STAFF REPORT
COMMUNITY DEVELOPMENT DEPARTMENT

HEARING DATE: 4/26/2022
TO: Mayor & City Council
FROM: Alan Tiefenbach, Associate Planner
208-498-0573
SUBJECT: SHP-2022-0005
Katsura Subdivision Short Plat
LOCATION: Lot 2, Block 2 of the Medimont Subdivision No. 1, and 225 and 335 S. Locust Grove Rd.

The Applicant proposes a Short Plat to create one buildable lot and two common lots on approximately 3.8 acres in the I-L zoning district.

KATSURA SUBDIVISION

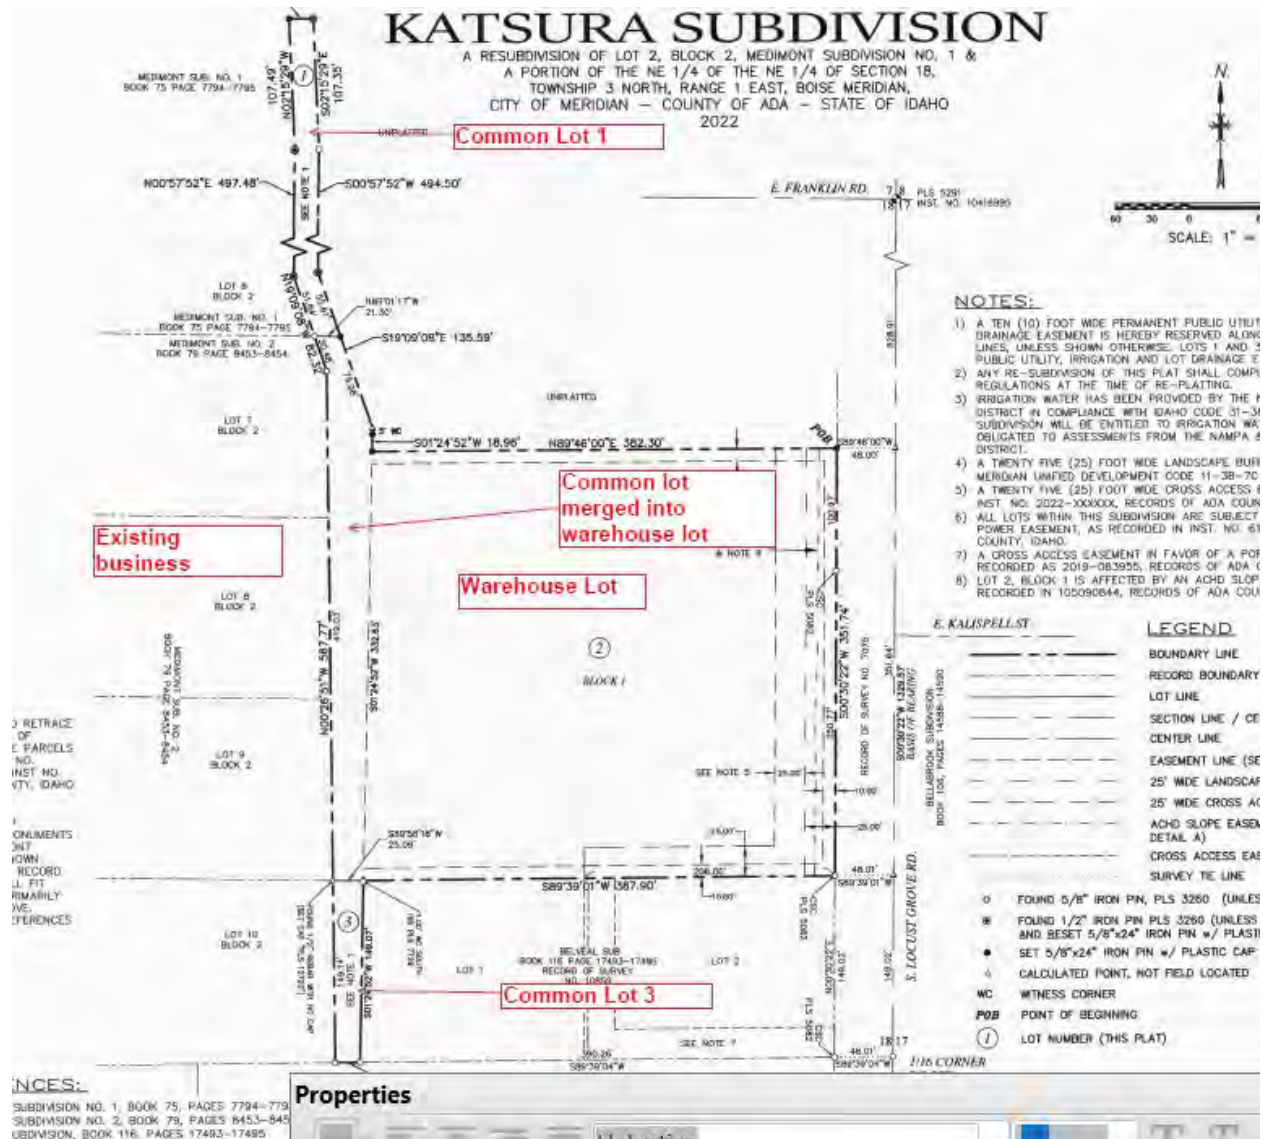
1. The short plat prepared by Kerry Albright of Forsgreen Associates Inc included in Section VI.B shall be revised as follows:
 - a) Add a note to the plat that specifies the shared access between Lot 2 Block 1 of the Katsura Subdivision and Lots 7 and 8 Block 2 of the Medimont Subdivision No 2. or graphically depict a cross-access/ingress-egress easement in accord with the provisions of UDC 11-3A-3A2.

- b) Note 5: add instrument number.
2. Applicant shall comply with all previous conditions of approval associated with this development (H-2021-0042, DA Instr. 2022-001274).
